ALERT SERVICE BULLETIN

Exchange of exhaust valves on ROTAX® Engine Types 915 i A, 915 i B (Series) and 914 (Series)

ATA System: 72-00-00 Engine

Fig. 1
Exchange of exhaust valves

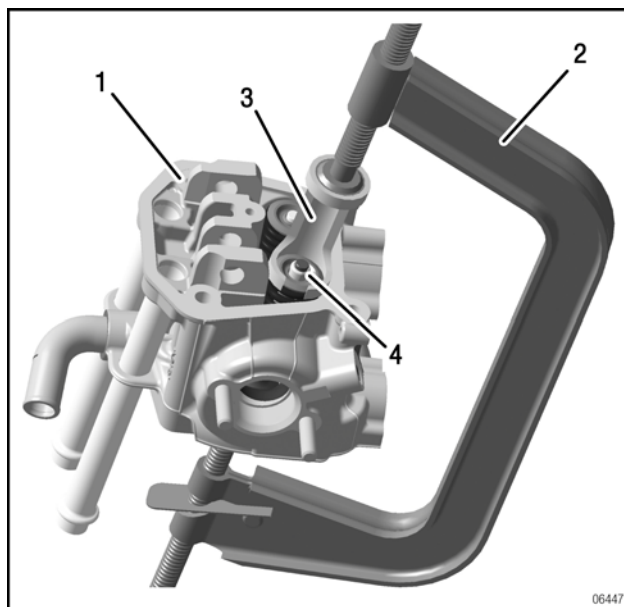
| Step | Procedure |
|------|--|
| 1 | Remove the affected exhaust valves according to relevant Maintenance Manual Heavy (MMH). |
| 2 | Install new exhaust valves according to relevant Maintenance Manual Heavy (MMH). |

Fig. 2
Identification of exhaust valves

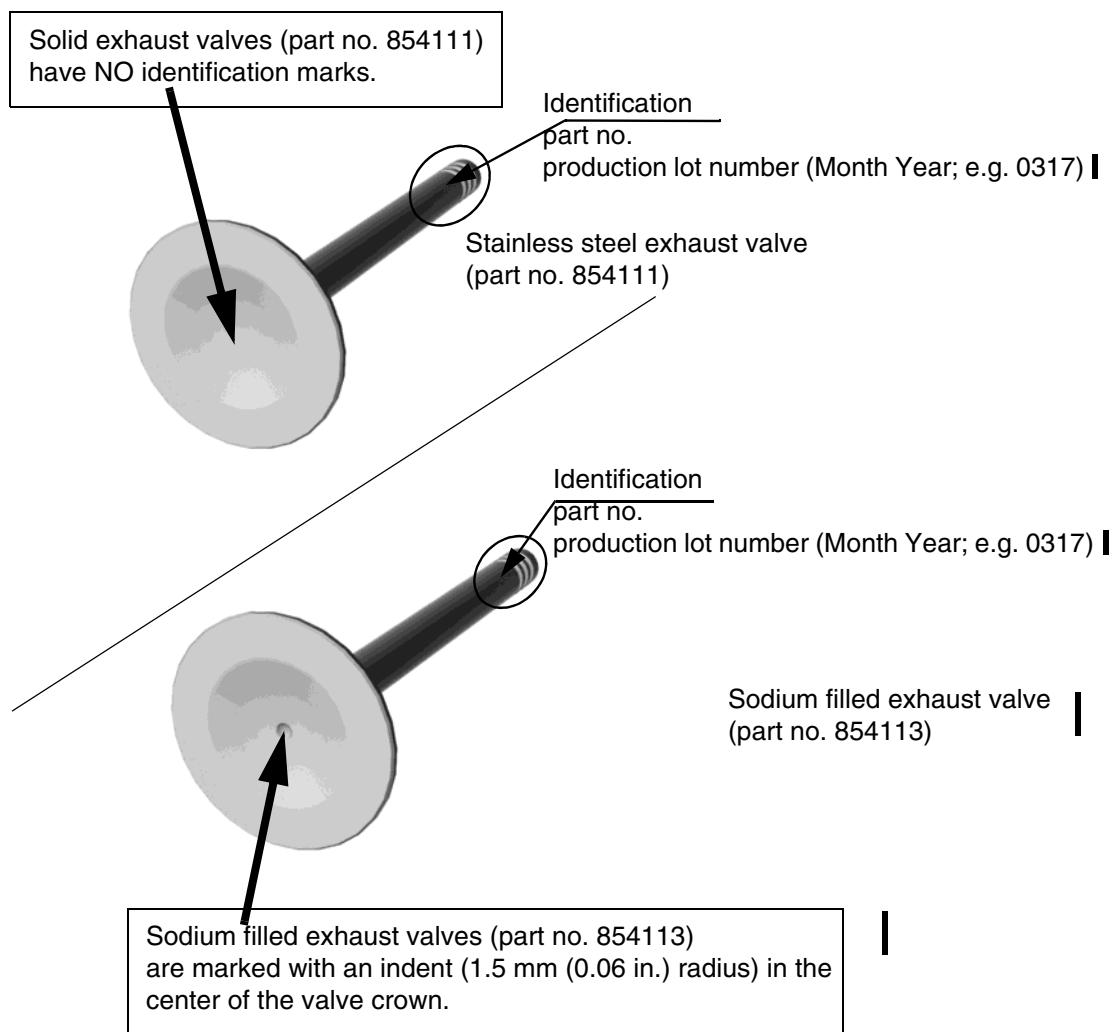
The engines below have been fitted by the manufacturer with an exhaust valve 32 mm (1.26 in.) part no. 854113 with a variety of production lots from which the production lot numbers 0317 and 0517 (see Fig. 2) are affected.

All engines are affected, which have been equipped with an exhaust valve 32 mm (1.26 in.) with part no. 854113 with a production lot number 0317 and 0517 during engine repair, maintenance or general overhaul (see Fig. 2).

Due to deviations in the manufacturing process of the exhaust valve 32 mm (1.26 in.) with part no. 854113 (for production lots affected see section 1.1) an exhaust valve cracking / fracture may occur. In consequence this may result in a malfunction of the valve train and a subsequent engine stoppage.

- All affected parts cannot further be used and must be marked unserviceable. These parts must be returned FCA (Free CArrier) to ROTAX® Authorized Distributors or their independent Service Centers
- Further sale, use or shipment of all affected exhaust valves part no. 854113 (see section 1.1) in stores (e.g. replacement parts) is not allowed and must be returned FCA to ROTAX® Authorized Distributors or their independent Service Centers
